PROPOSED AMENDMENT TO TECHNICAL SPECIFICATION

SECTION 3/4.3.2

PALO VERDE NUCLEAR GENERATING STATION

FIGURE 3.3-1

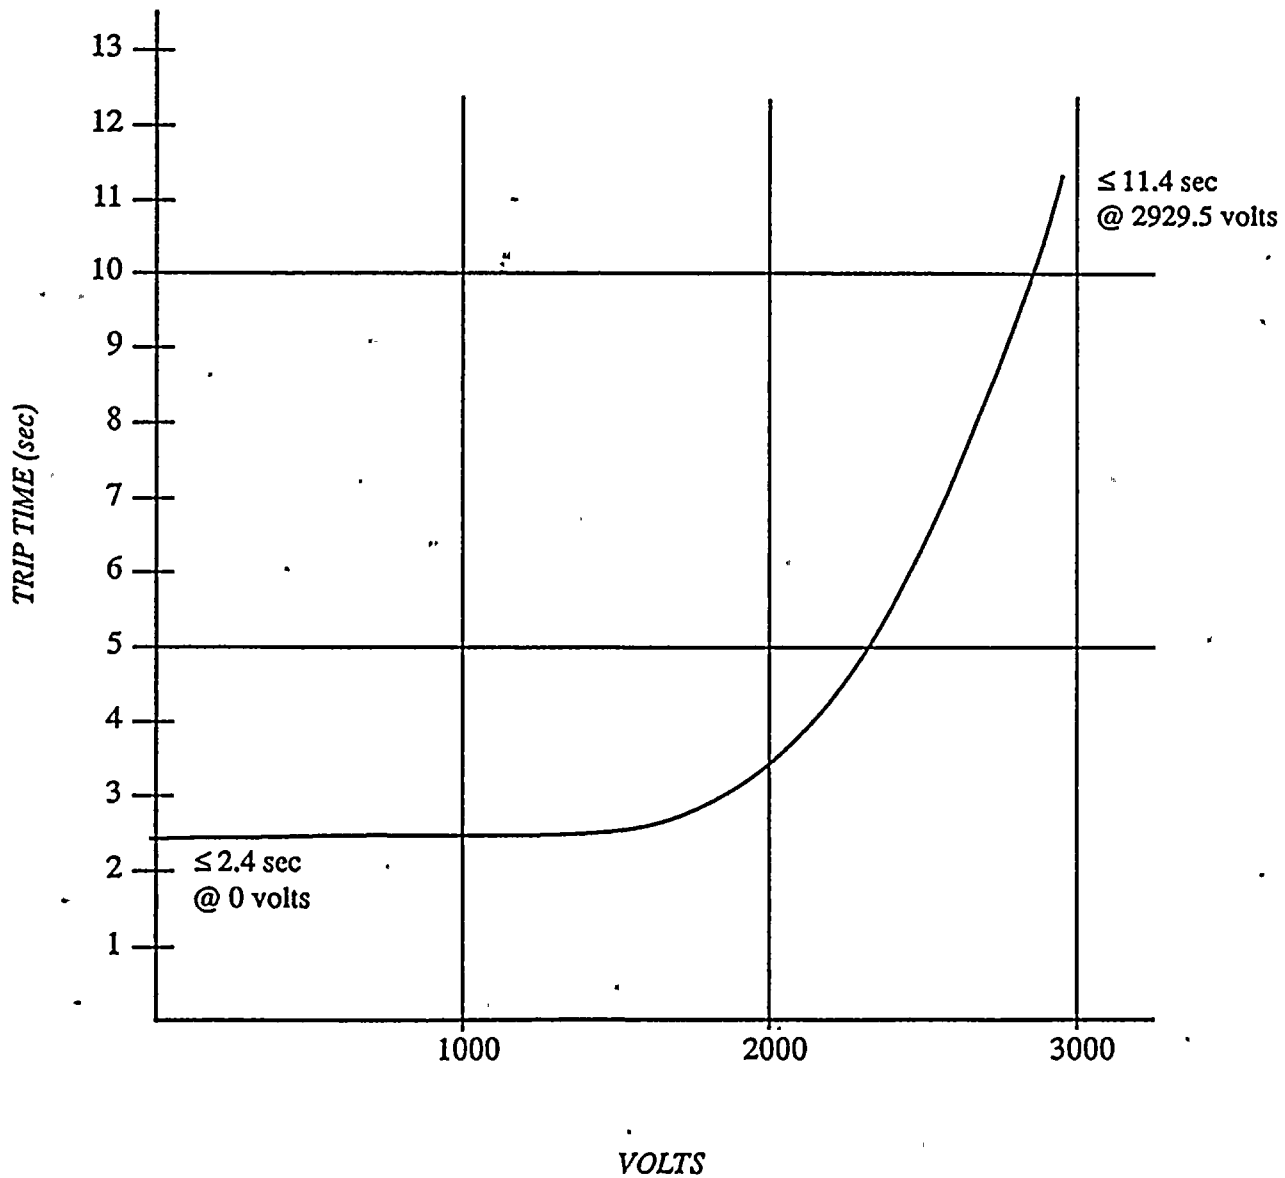
The proposed TS amendment adds Figure 3.3-1, "LOSS OF VOLTAGE RELAY (GE IAV) TIME VS VOLTAGE CURVE."

The addition of Figure 3.3-1 improves the clarity of the undervoltage relay requirements and does not affect nuclear safety.

LOSS OF VOLTAGE RELAY (GE IAV) TIME VS VOLTAGE CURVE

See Table 3.3-4 item VIII A.

See Table 3.3-5 item 12
